**METROPOLITAN GOVERNMENT OF NASHVILLE AND DAVIDSON COUNTY**

**STAFF RECOMMENDATION**  
**3927 Cambridge Avenue**  
**November 19, 2014**

**Application:** New construction-addition; Setback determination  
**District:** Cherokee Park Neighborhood Conservation Zoning Overlay  
**Council District:** 24  
**Map and Parcel Number:** 10308023100  
**Applicant:** Legacy Construction Inc.  
**Project Lead:** Robin Zeigler, robin.zeigler@nashville.gov

<p><b>Description of Project:</b> The project is to construct a partially-screened rear porch fully in the rear setback area. The new rear setback is proposed to be five feet (5').</p> <p><b>Recommendation Summary:</b> Staff recommends disapproval finding that the project does not meet the Commission's policy for determining rear setbacks that are different from bulk zoning or the design guidelines for open space, and because approval could set a precedent for fully building out the rear setback areas of other properties nearby. In summary, the project does not meet Sections II.B.b and II.B.2 for scale, location of an addition, and setbacks.</p>	<p><b>Attachments</b> <b>A:</b> Photographs <b>B:</b> Site Plan <b>C:</b> Elevations</p>
---	--

Figure 3: Shows the close proximity of homes in this area.

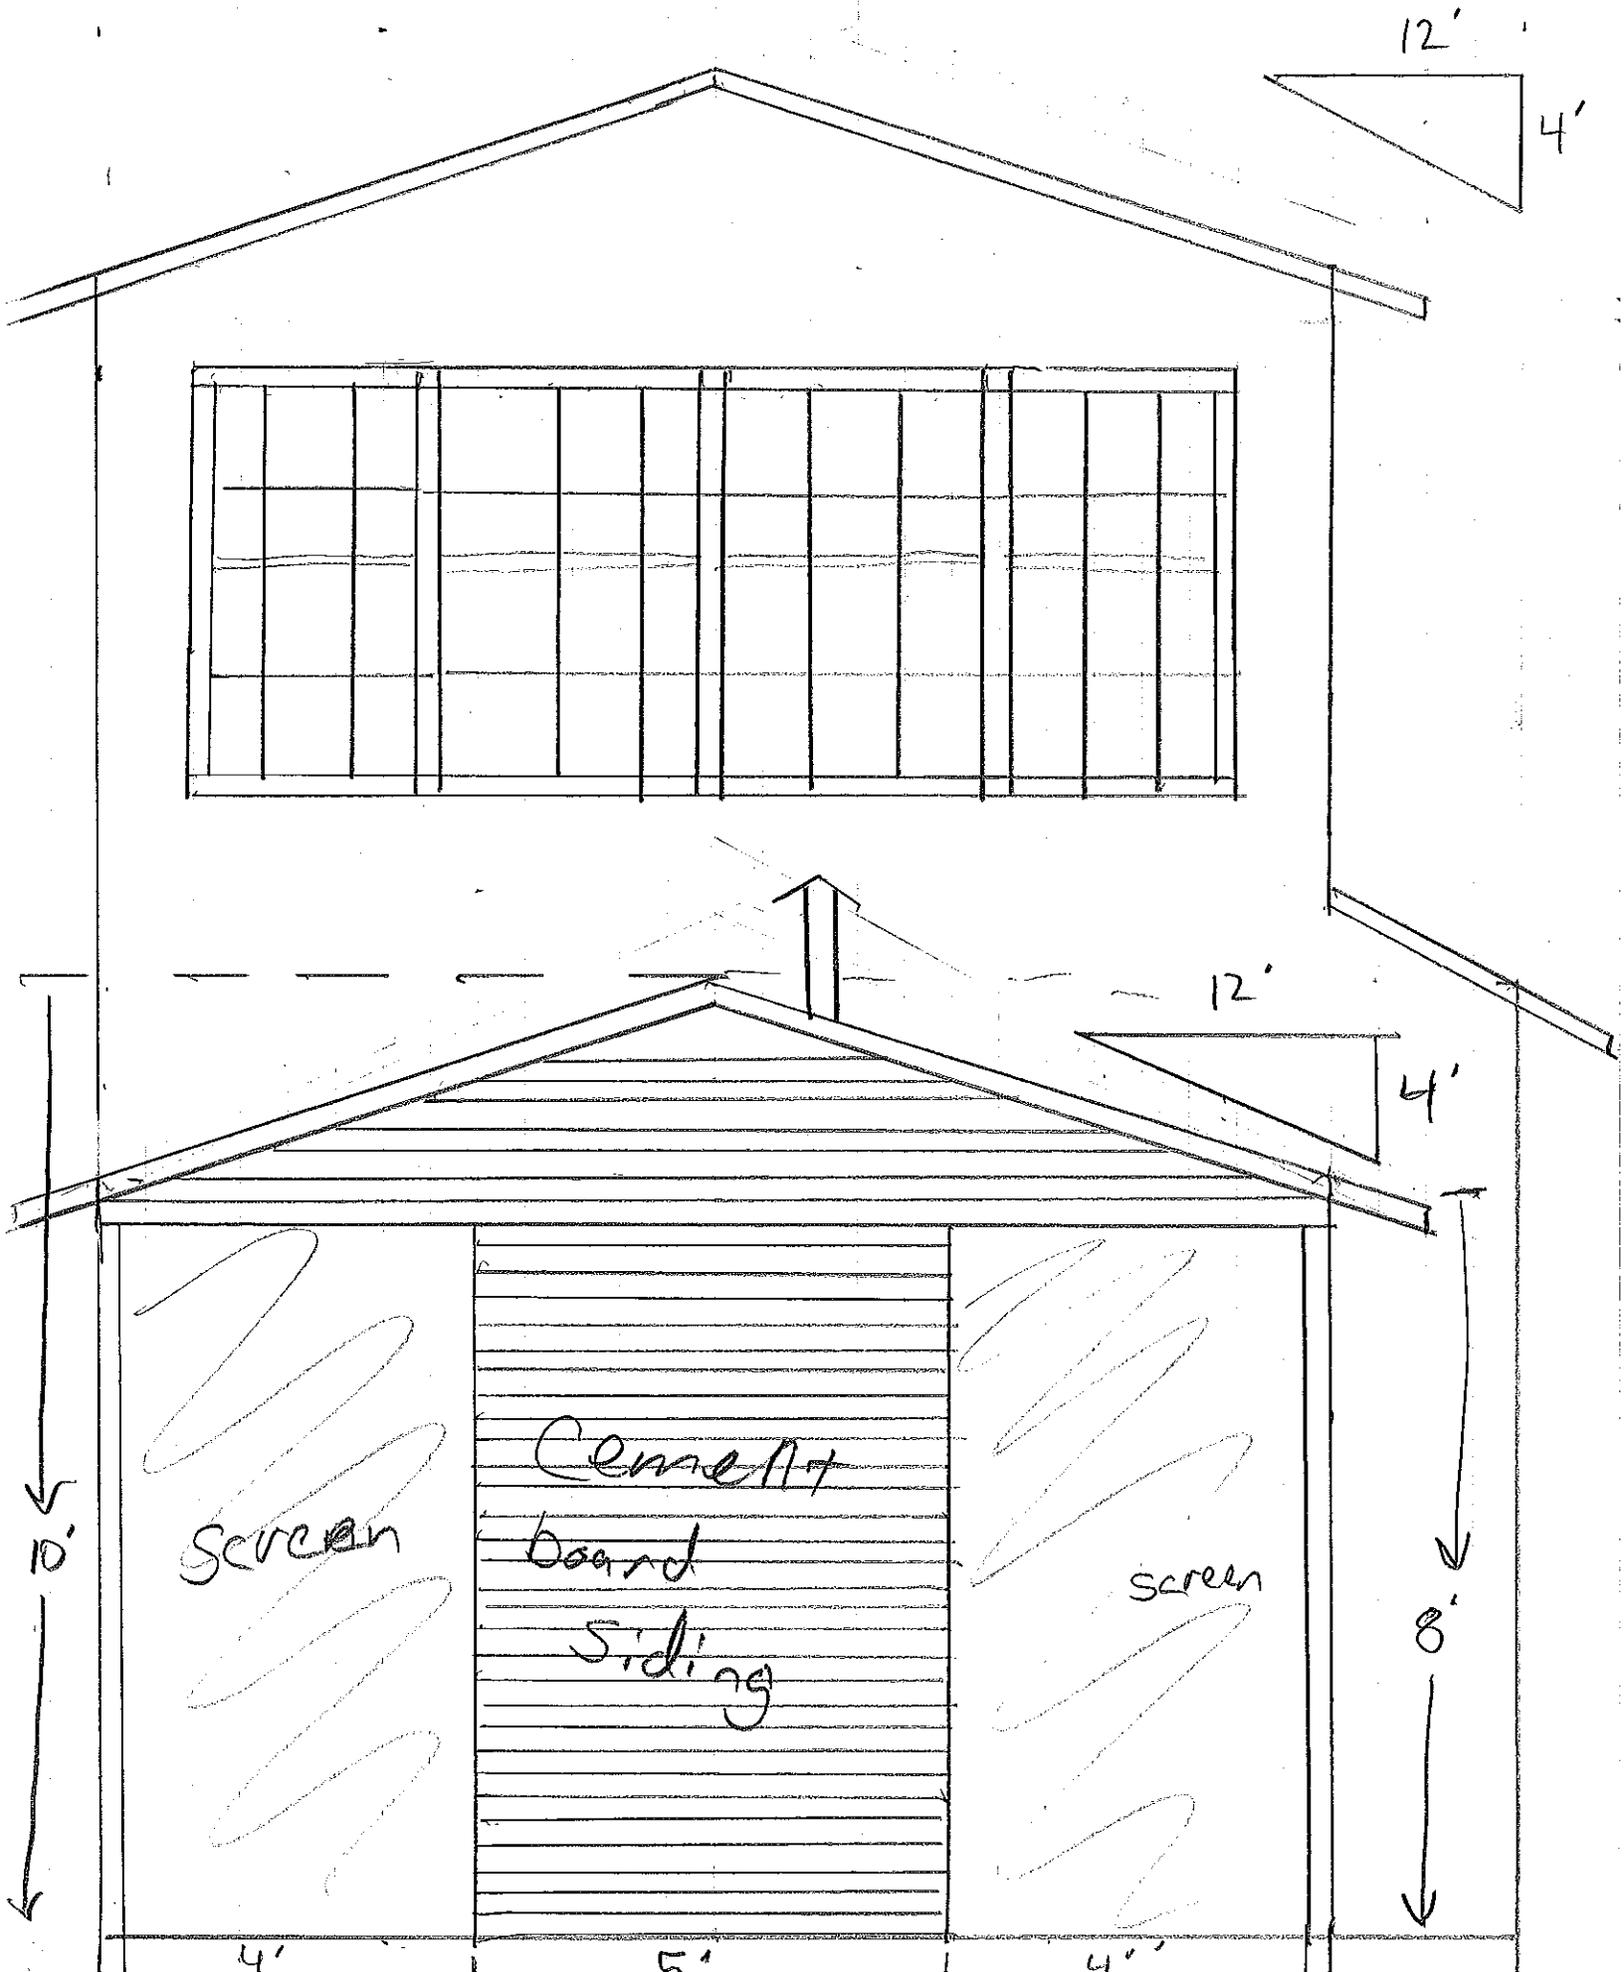
**Setback & Rhythm of Spacing:** The project meets side-setback requirements but does not meet the policy for granting rear setback determinations that are different than bulk zoning. The Commission has the ability to determine appropriate building setbacks that may not conform to the base zoning for new construction, additions, and accessory structures (ordinance no. 17.40.410). In 2007, the Commission approved a rear addition

that intrudes into the rear setback area a minimal amount. The Commission created a policy that states appropriate setbacks will be determined based on the existing setbacks, historic setbacks, the shape of the lot, alley access, or lack thereof, and the proximity of adjoining structure and property lines. Since there is no rear alley, there is no opportunity to provide an additional buffer between this property and the one behind it. The lot is approximately one hundred and two feet deep, which is similar to other lots in the immediate vicinity. Staff did not find that the request does not meet the Commission's requirements of unusual conditions and finds that it could set a precedent for similar neighboring lots. The project does not meet section II.B.1.c.

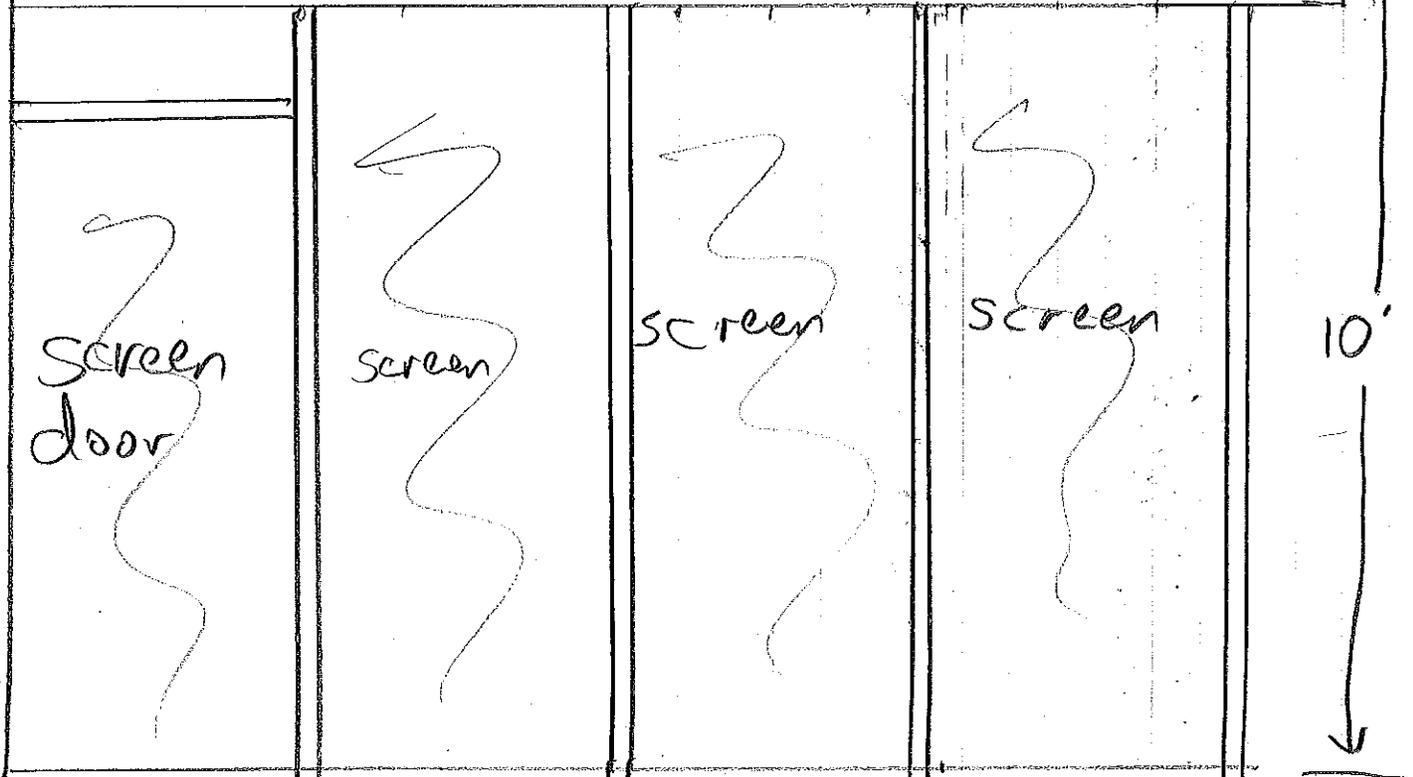
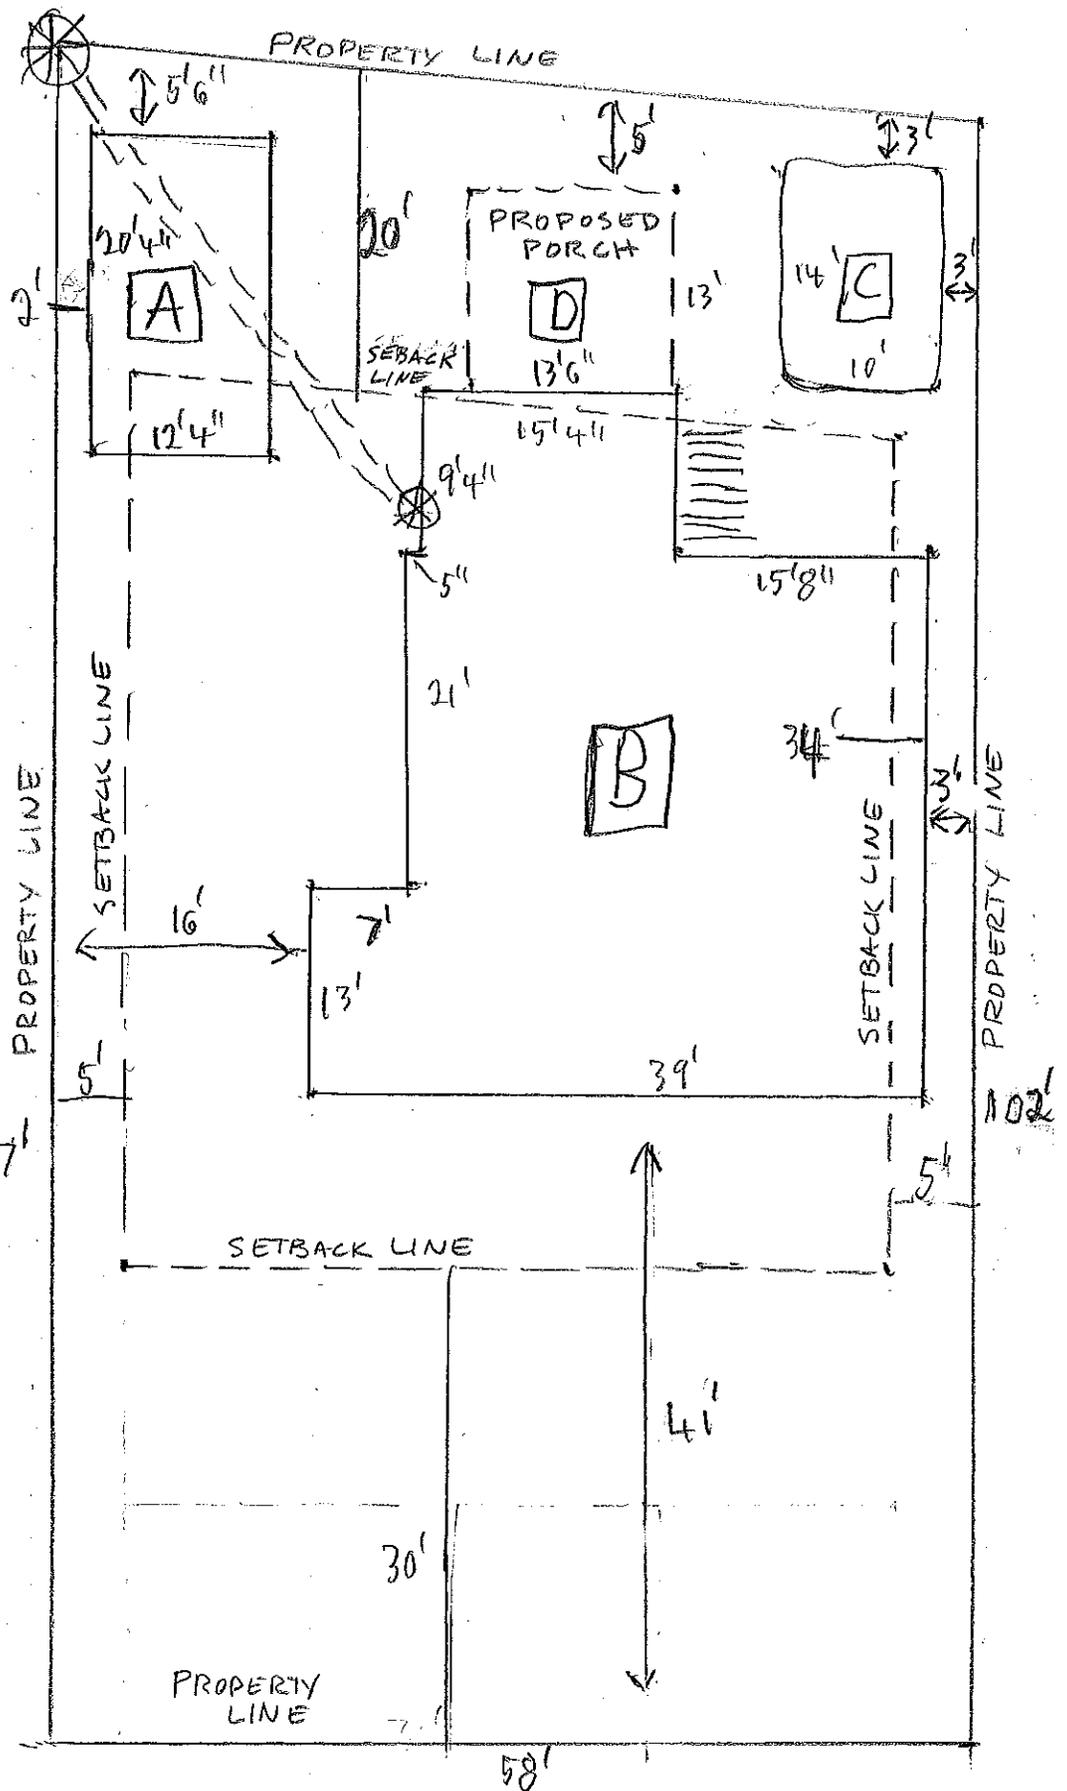
Materials: The majority of materials are not indicated. The portion to be covered in lap siding will be cement-fiber lap siding of an unknown reveal. With the information provided, staff could not assess whether or not the project meets section II.B.1.d

Roof form: The roof form will be gabled of a similar pitch (12/4) to the rear addition. The project meets section II.B.1.e.
